# Response to Stakeholder Comments on the Boston 2028 RFP – Review of Phase One Proposals

This document captures stakeholder comments submitted to [pacmatters@iso-ne.com](mailto:pacmatters@iso-ne.com) in response to the presentation by Brent Oberlin to the Planning Advisory Committee (PAC) on June 17, 2020 titled “Boston 2028 RFP – Review of Phase One Proposals,”<sup>1</sup> the June 16, 2020 posting of the “Draft Boston 2028 RFP – Review of Phase One Proposals,”<sup>2</sup> and the ISO responses to the stakeholder comments.

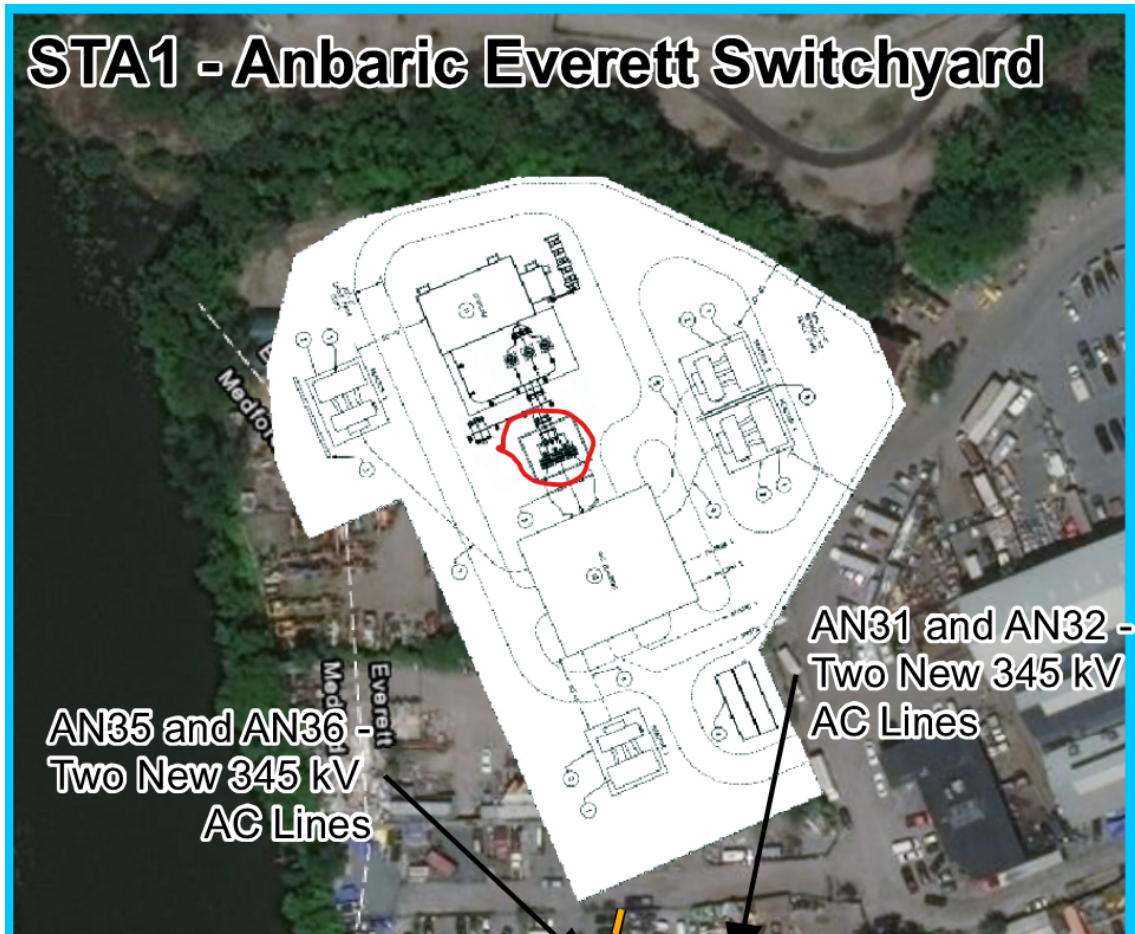
Slide 74 of the ISO-NE Presentation asserts that “Anbaric AC response is missing a required listing of a step-up transformer. This is incorrect. The step-up transformer is clearly identified on the project one-line in Section 4.3<sup>6</sup> on page 32 (see Figure 1 below) with the transformer symbol item marked “T” within the STATCOM box referring to the step-up transformer:

Anbaric’s response to item 4.1 identifies the STATCOM as a 345kV element. The transformer is included in that element and is part of its cost. A STATCOM includes a transformer as part of the kit supplied by a vendor. The transformer is clearly shown on the one-line and the diagram above and any experienced planner would know that STATCOMs with step-up transformers are typically purchased as turn-key kits from vendors. These turn-key kits include all necessary components, including transformers. Therefore, ISO-NE’s rejection of Anbaric’s AC response is factually incorrect.
